Item 8.**Section 4.56 Application: 163-173 McEvoy Street, Alexandria – D/2017/238/A**

File No.: D/2017/238/A

Summary

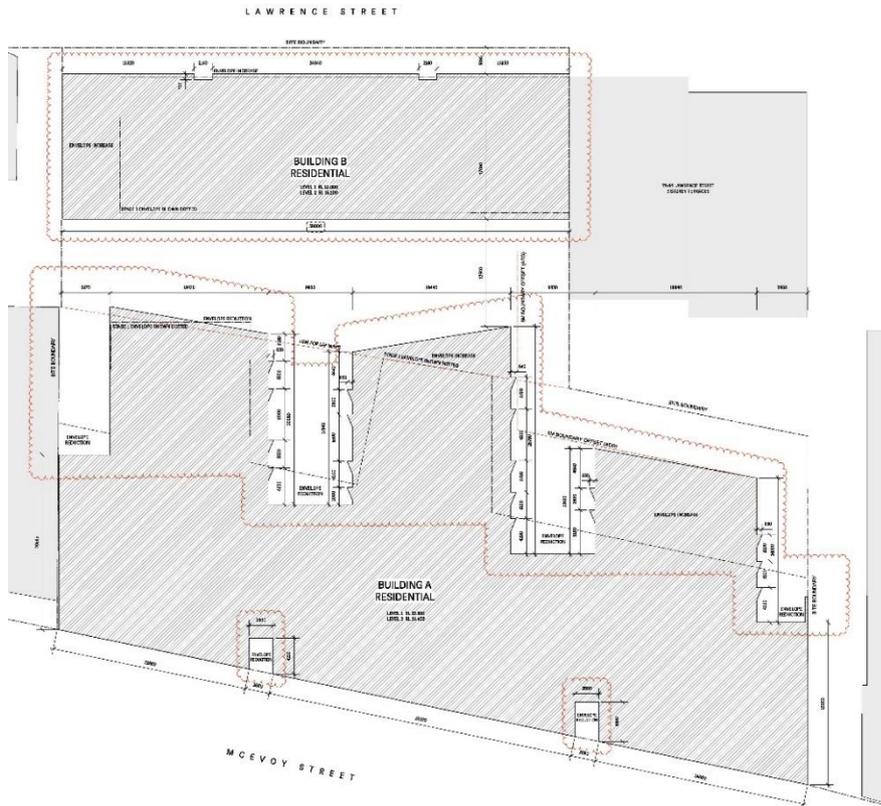
Building B:

- Reduced FFL RLs for both levels

Figure 2: Proposed Level 1 and 2 envelopes

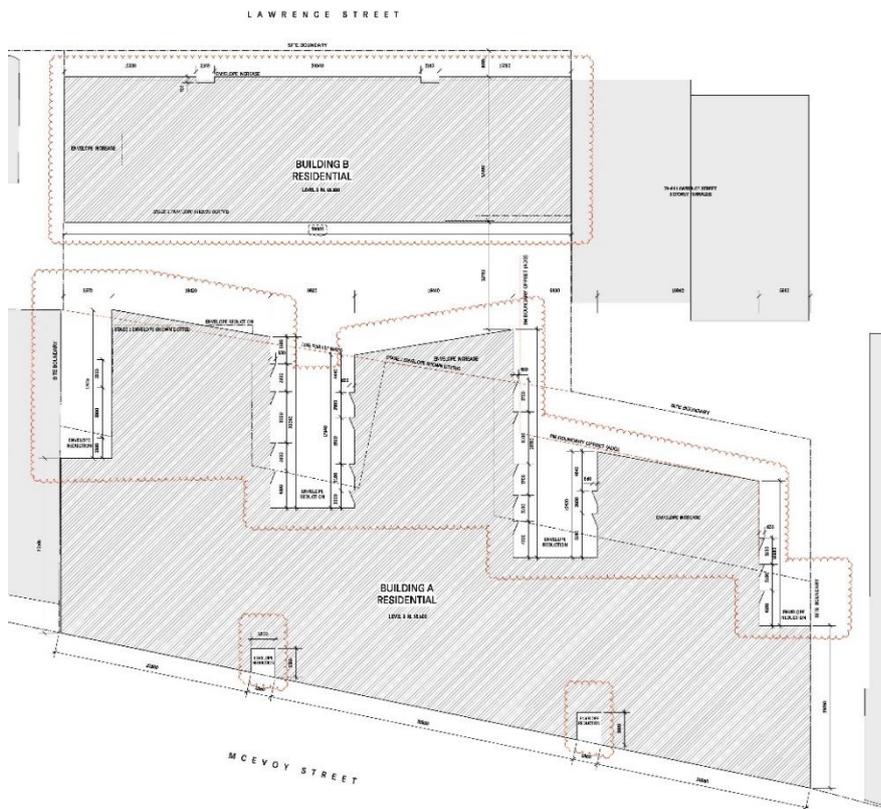
Building B:

- Reduced FFL RL

Figure 3: Proposed Level 3 envelope

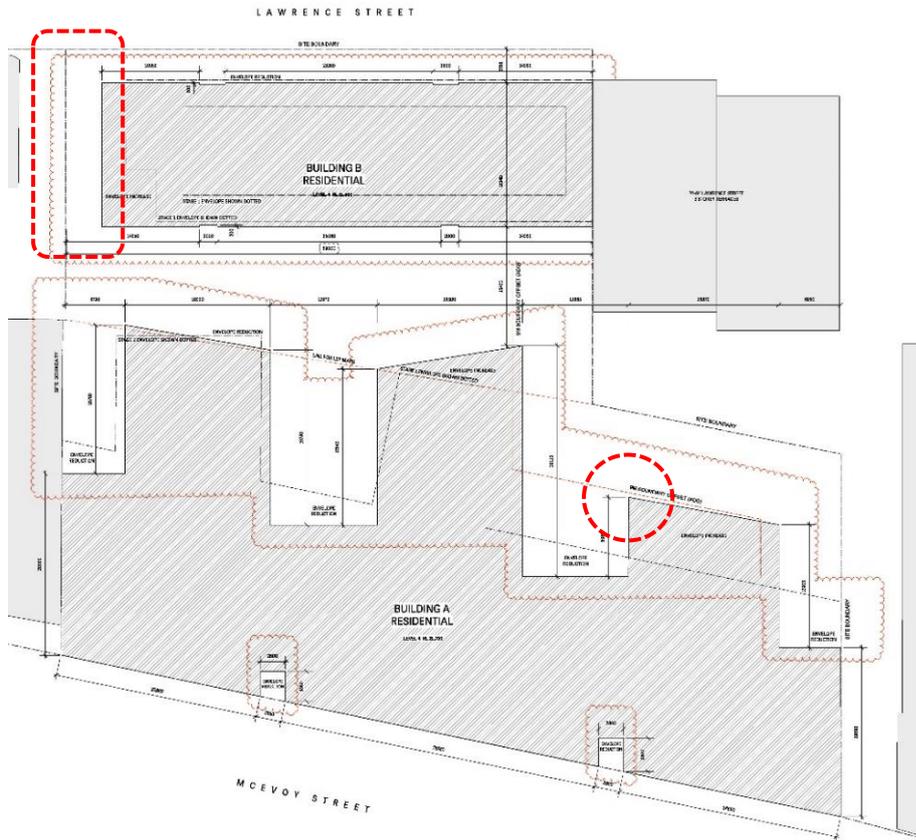
Building A:

- Deletion of return on north eastern bay

Building B:

- Additional level
- 4m setback to south western boundary

Figure 4: Proposed Level 4 envelope

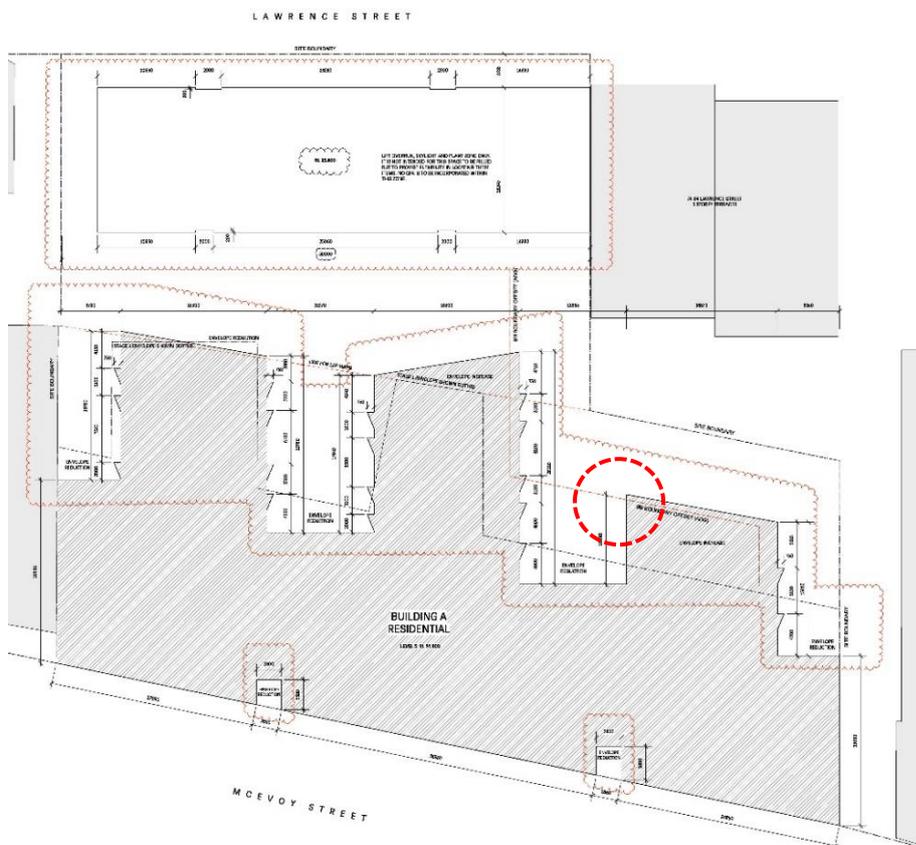
Building A:

- Deletion of return on north eastern bay

Building B:

- Increased roof RL

Figure 5: Proposed Level 5 envelope

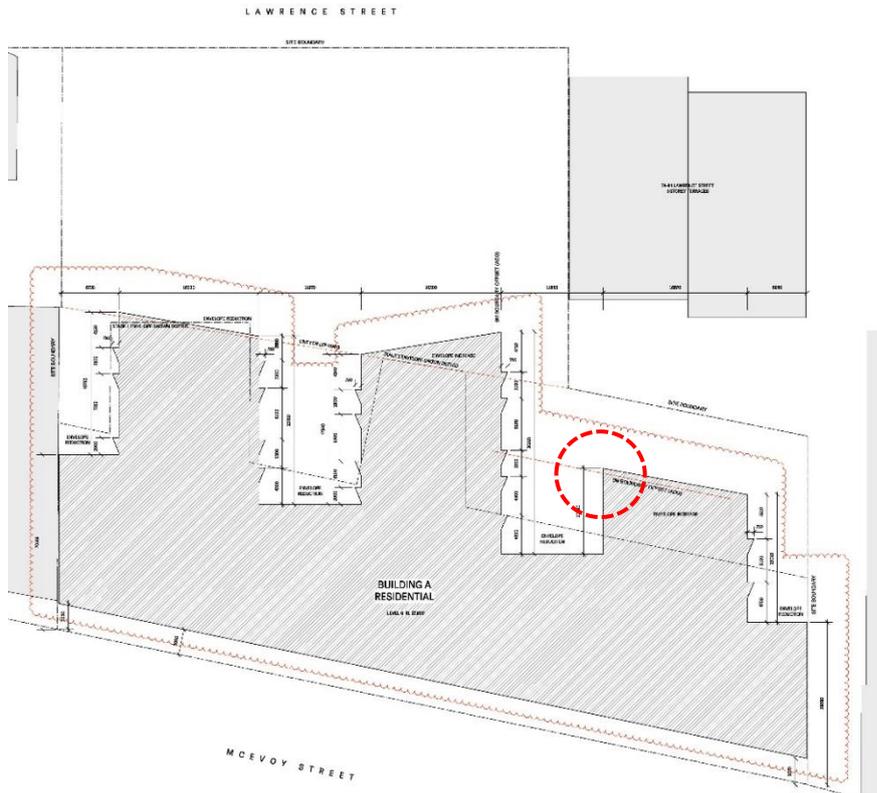
Building A:

- Deletion of return on north eastern bay

Figure 6: Proposed Level 6 envelope

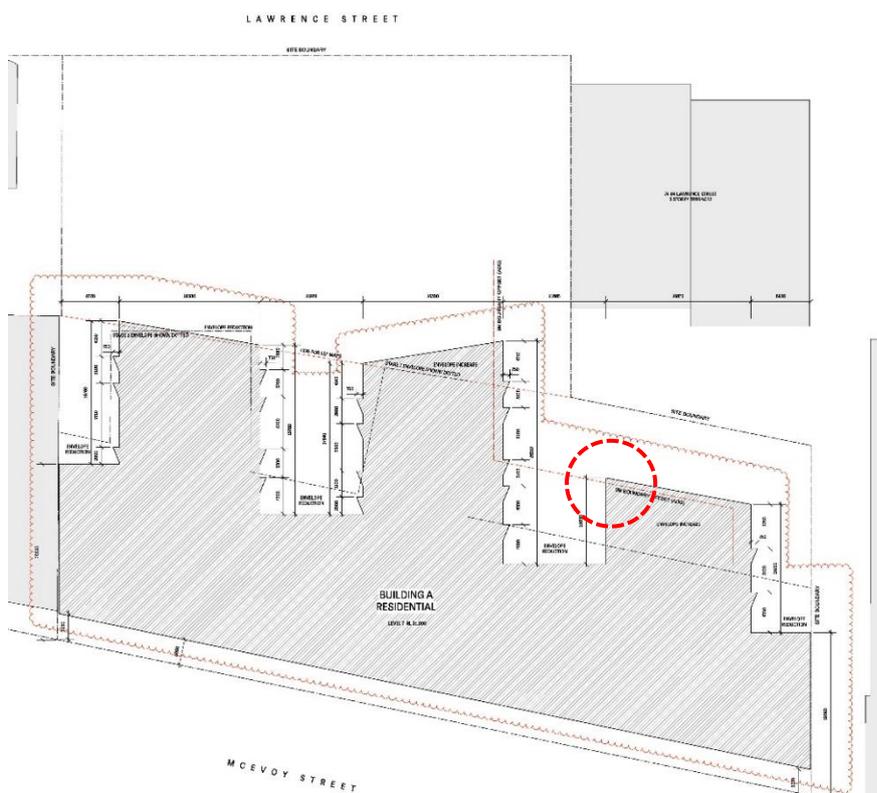
Building A:

- Deletion of return on north eastern bay

Figure 7: Proposed Level 7 envelope

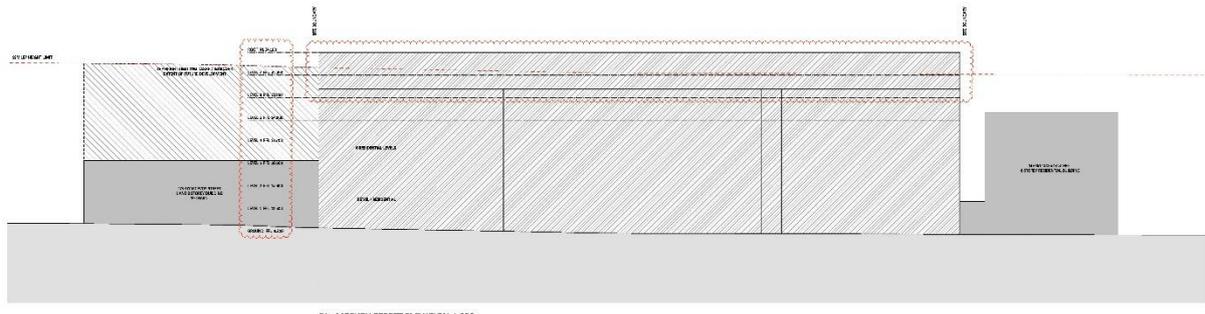
Building B:

- Additional level
- 4m setback to south western boundary
- Amended RLs

Figure 12: Proposed variation to LEP building height control – Building B

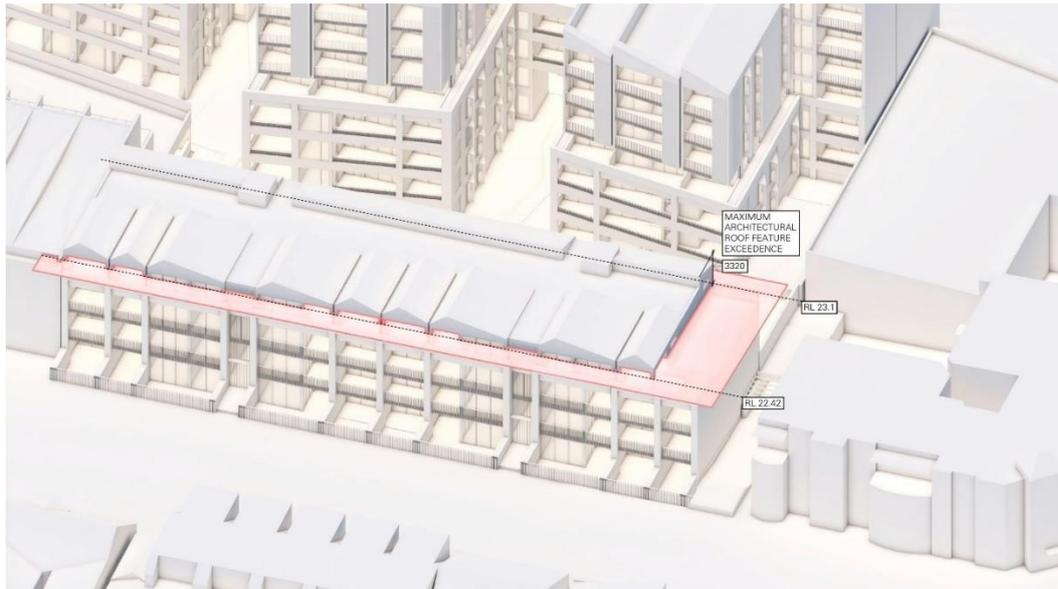
- (a) The application proposes exceeding the maximum 12m LEP height of building development standard by 3.32m. The extent of the non-compliance is illustrated in Figure 12.

Figure 14: Building B: Section of amended modification (existing ground level in blue)

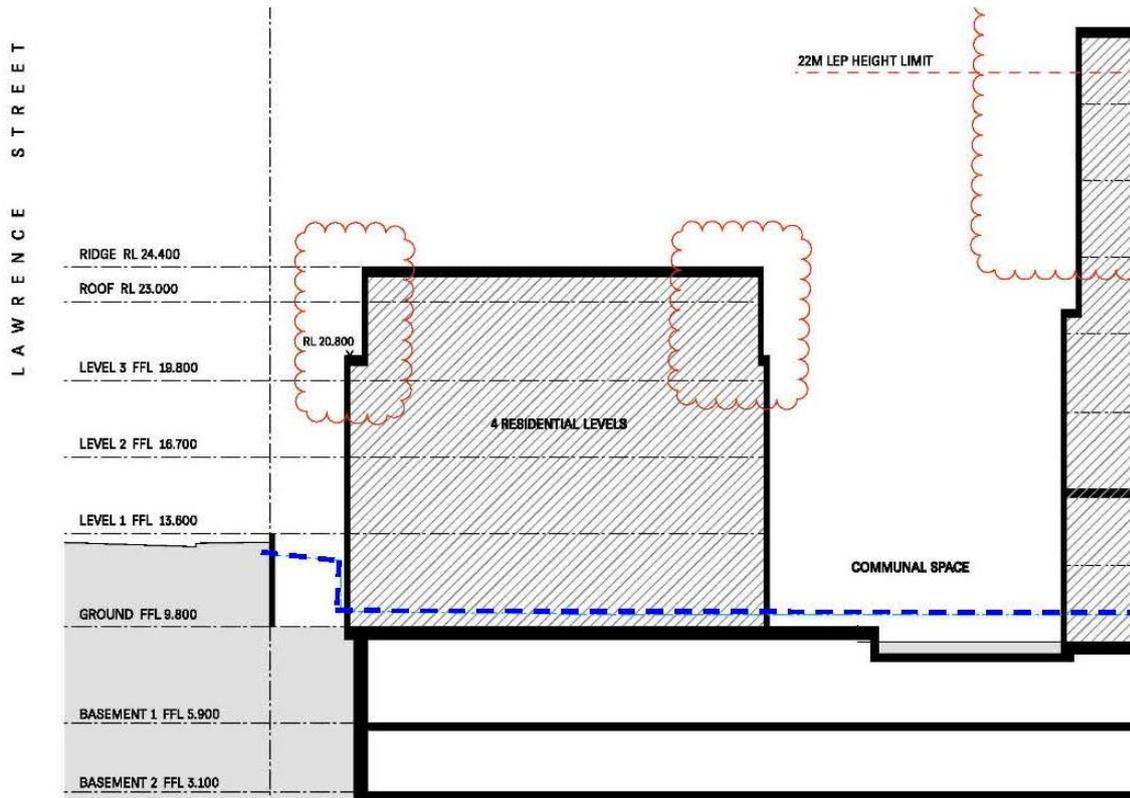
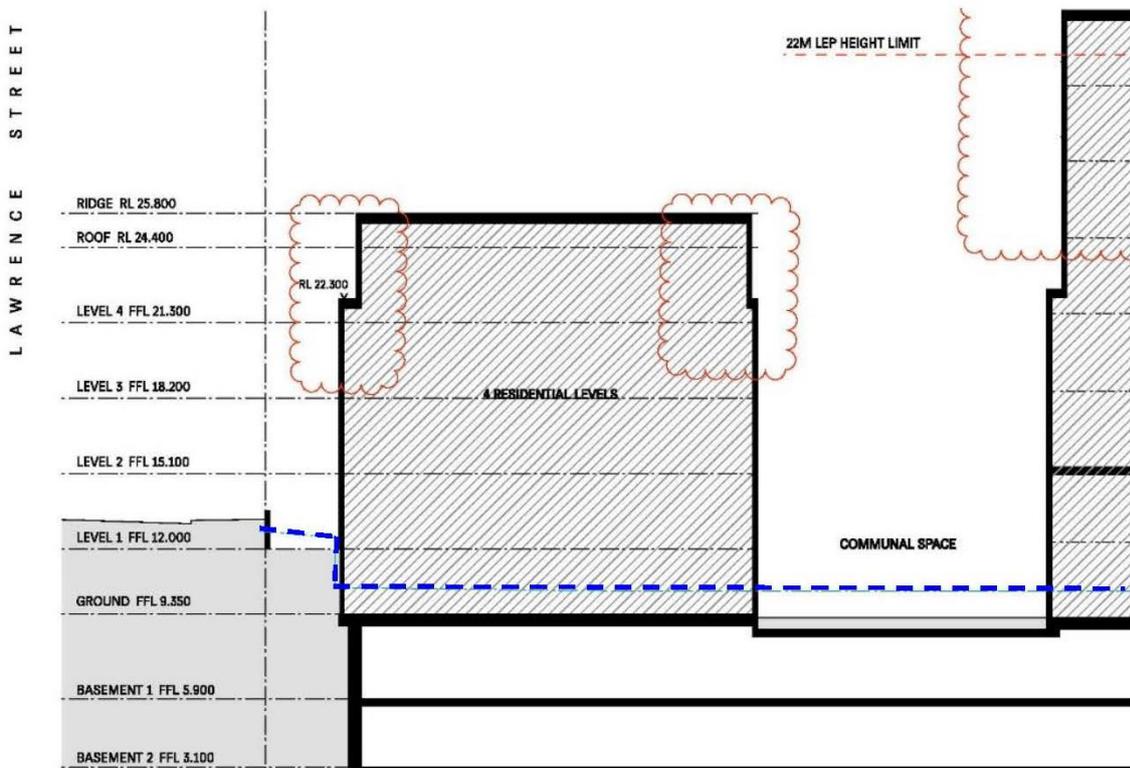
- (b) The original modification presented to CSPC in July set maximum building heights in RLs that corresponded to a building that presented as 3 storeys to Lawrence Street and 4 storeys to the internal courtyard (Figures 13 and 15).
- (c) The modified envelope presents a 3.5 storey form to Lawrence Street and 5 storey form to the internal courtyard (Figures 14 and 16).
- (d) The amended modification shows the floor level of Level 1 (being the first level of apartments) approximately 1.2m below street level, whereas previously apartments were proposed approximately 3.4m below street level on the Ground Floor. As shown in the detailed design application, the Ground Floor of Building B is to accommodate storage, a pool and cabanas. No part of residential units are contained on the Ground Floor of Building B, as per Condition 5(k) of the original concept approval.

Figure 16: Building B: Lawrence Street elevation of amended modification

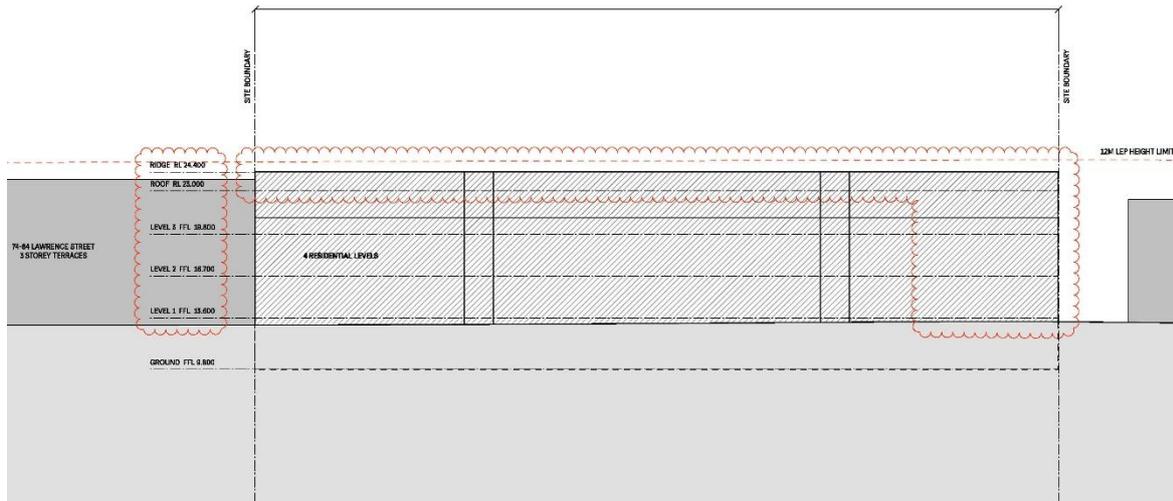
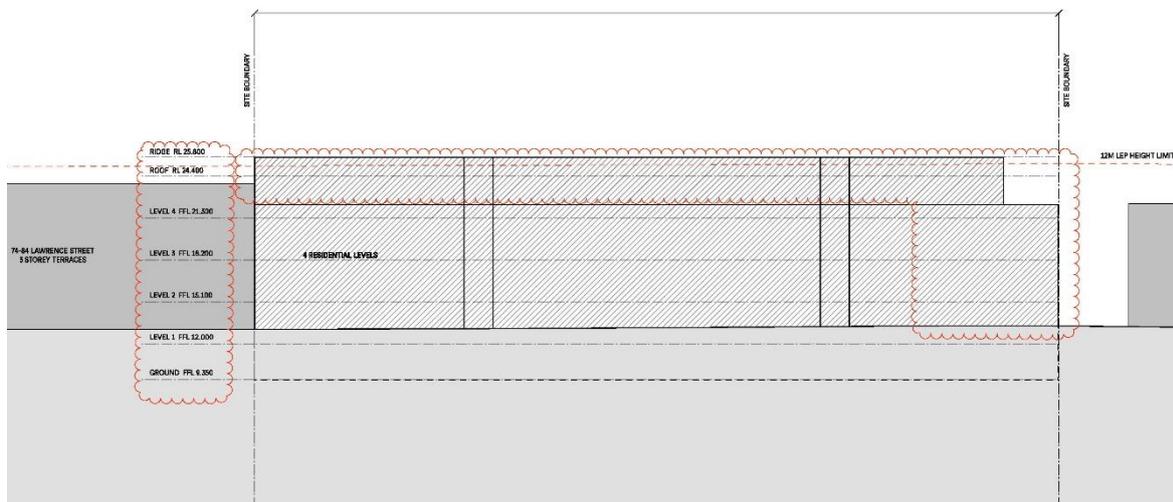
- (e) The modified envelope sits approximately half a storey above the existing 3 storey terraces located to the north east at 74-84 Lawrence Street. As demonstrated by the detailed design application and shown in Figure 12, the majority of Building B that sits above the 12m height control is comprised of architectural roof feature, which does not unreasonably add to the bulk and scale of the building when viewed from the public domain and surrounding buildings.

- (f) As shown in Figure 16, the modified envelope aligns with the height of the existing 3 storey residential flat building located to the south west at 118-136 Lawrence Street. This is due to the newly introduced 4m setback to the south western property boundary. This setback improves amenity for adjoining residents (as discussed further below) and delivers a built form that is consistent with the existing and future desired character of the area.

Figure 19: Proposed upper level 4m setback to south western property boundary

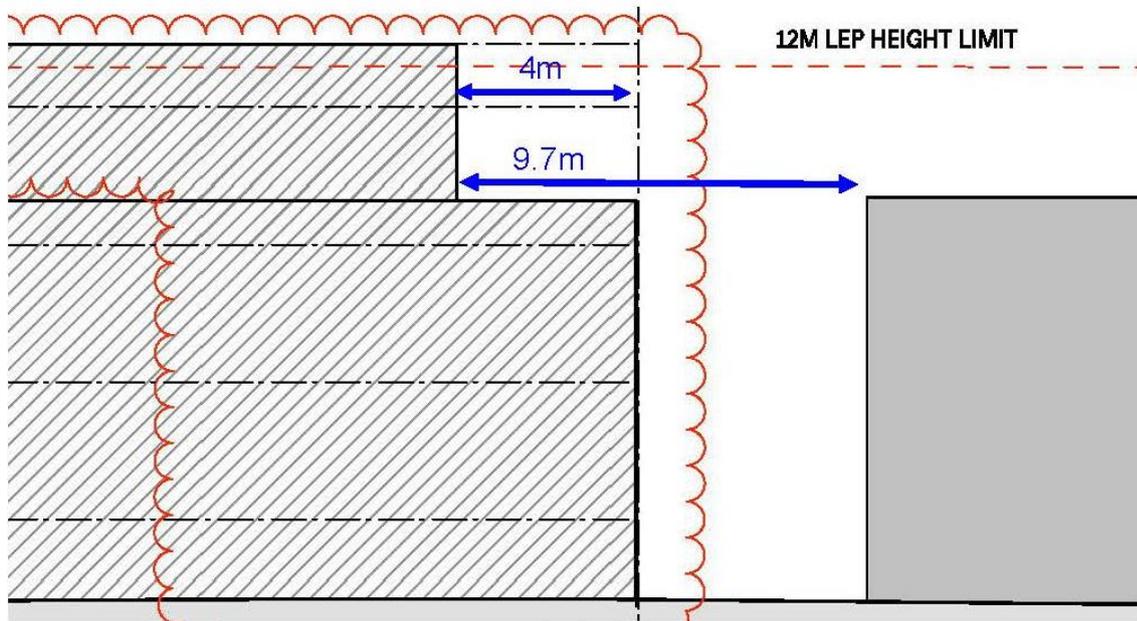
- (b) As shown in Figure 19, the amended modification incorporates a 4m setback to the south western property for the top floor. This setback has been provided to ensure the increased height to Building B does not result in additional overshadowing impacts to adjoining properties or reduced amenity for future occupants.

- (c) Further, as detailed in the detailed design application, the 4m setback offers an improved level of solar access to the neighbouring area of common open space, increasing the area of space that receives 2 hours of solar access from 61% to 63.6% under the amended proposed. This offers improved compliance with the ADG and SDCP 2012 minimum requirement of 50%.
